# **RICE** Operating Company

**RE: NOTIFICATION OF GROUNDWATER IMPACT**  
**VACUUM SWD SYSTEM, K-35-1 boot**  
**UNIT 'K', SEC. 35, T17S, R35E**  
**OCD CASE #1R425-03**

**RE: Investigation and Characterization Plan  
Vacuum K-35-1 Junction Box, UL K Sec 35 T17S R35E**

**Figure B-4 – Junction Box Removal Schematic Diagram**

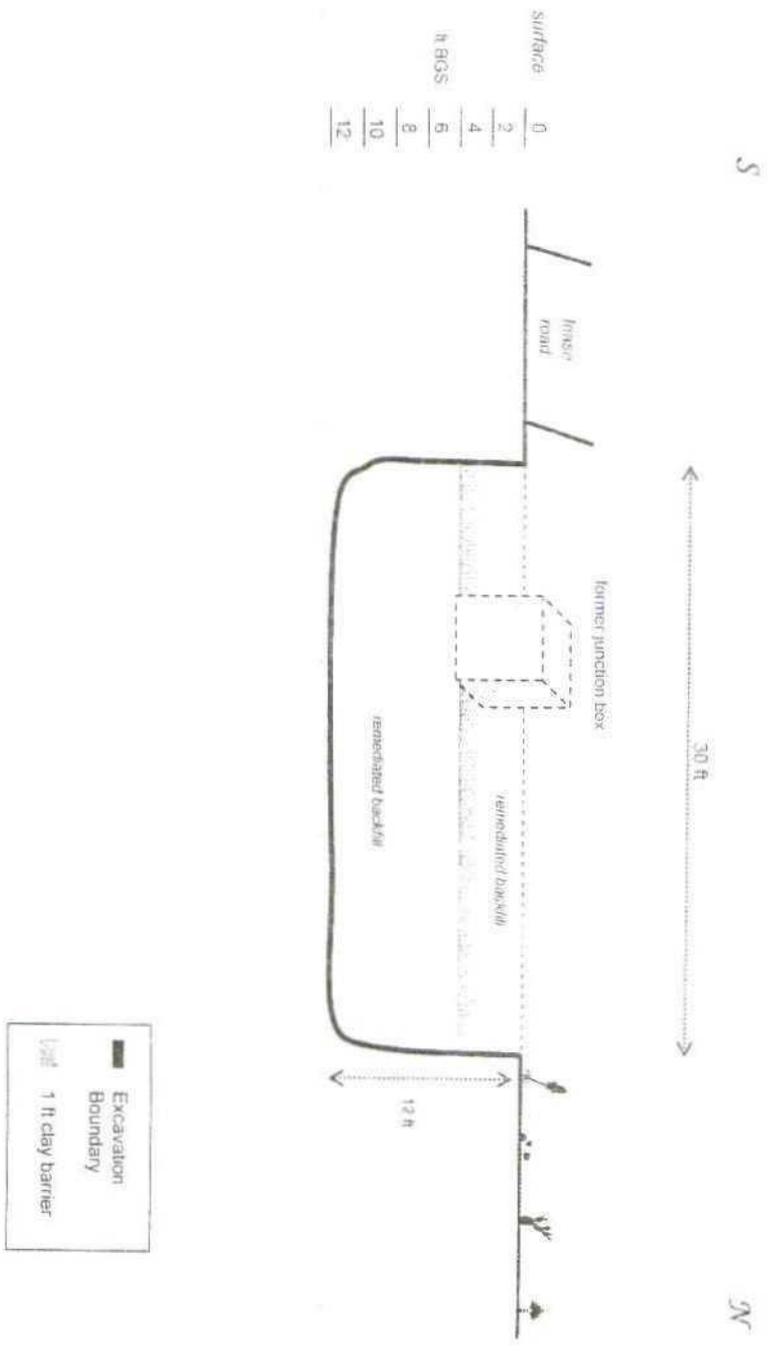
Please note that no soil material was hauled off the site, as it was simply backfilled into the excavation, as noted in the disclosure report. Thus, the clay barrier that was installed was simply as an interim precaution to preclude chloride migration. Subsequent investigation during the ICP will determine if this needs to be removed, redone, etc. We do plan to sample above and below this interim clay barrier.

Special Note: From looking at the disclosure report it appeared that chloride levels ranged from 479 to 6807. If this project was closed pursuant to "in accordance with the OCD-approved Junction Box Upgrade Work Plan (Rev. July 2003)" which only allow soils containing 1000 ppm chlorides there may be an issue of proper closure. Please investigate this issue and explain why the clay barrier was placed before final investigation. Also explain why this closure did not follow the Jct Box work plan.
